STAFF REPORT

SUBJECT: FP-2022-0025
Grayson Subdivision FP

LOCATION: Located at 1710 E. Amity Road, near the northeast corner of E. Amity Road and S. Locust Grove Road, in the SW 1/4 of the SW 1/4 of Section 29, Township 3N, Range 1E.

B. Final Plat (date: 7/6/2022)

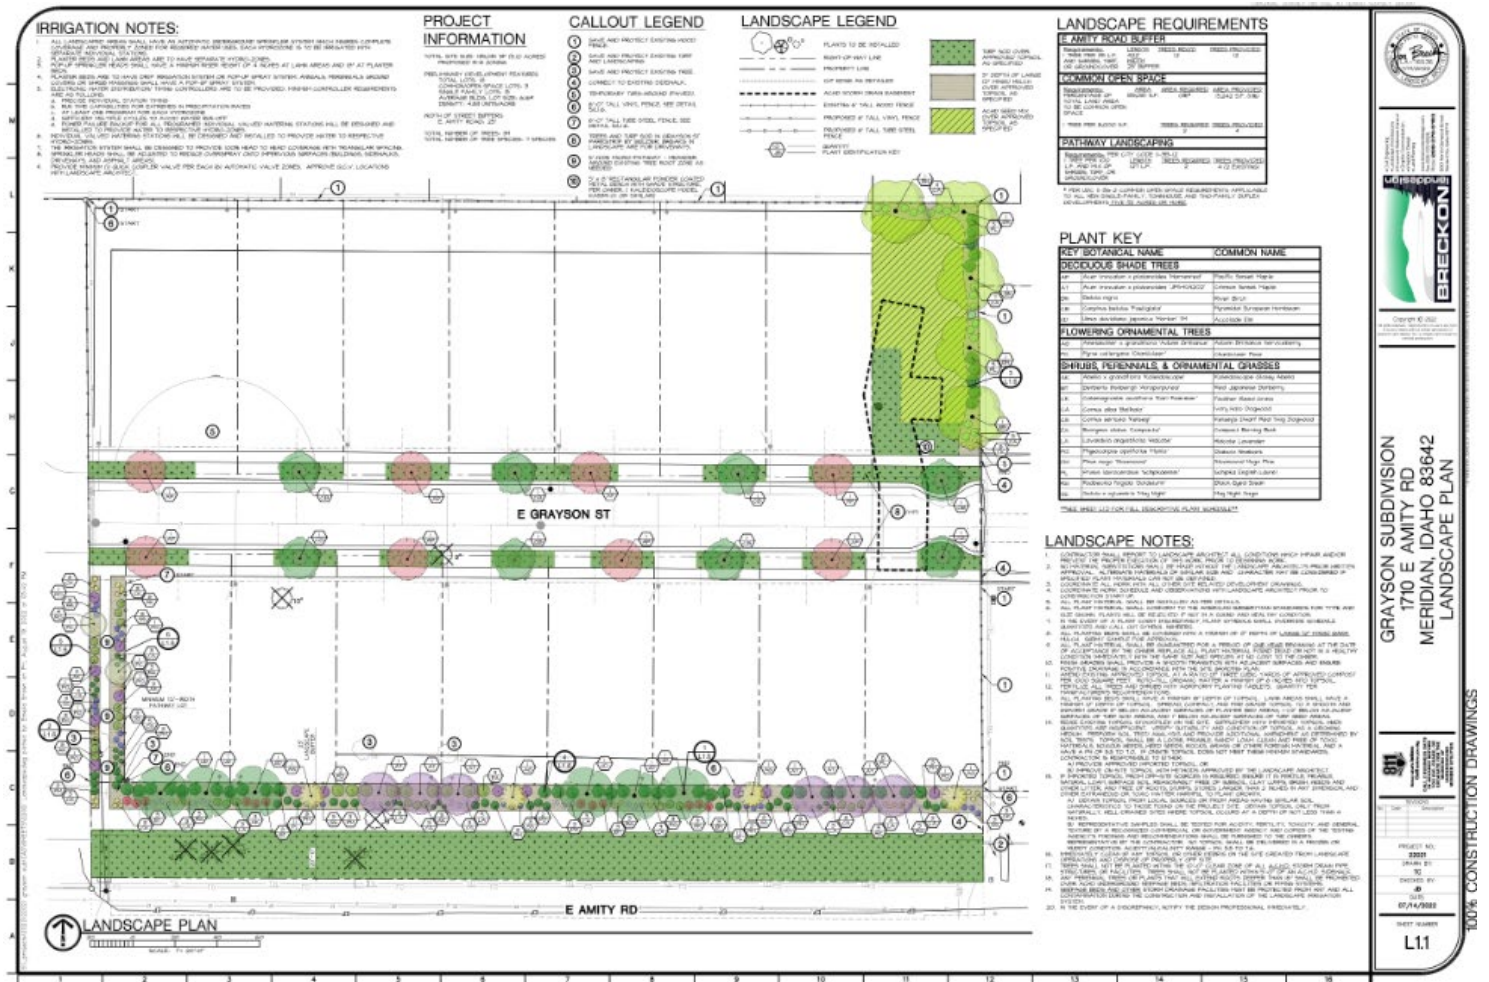
3. Prior to submittal for the City Engineer's signature, have the Certificate of Owners and the accompanying acknowledgement signed and notarized.
4. The final plat shown in Section V.B, prepared by Idaho Survey Group, stamped on April 26, 2022 by Michael S. Byrns, is approved with the following conditions to be completed at the time of Final Plat Signature:

- a. Plat note #7: add recorded instrument number.
 - b. Plat note #8: add recorded instrument number.
 - c. Plat note #9: include recorded instrument number (DA Inst. # 2022-066862).
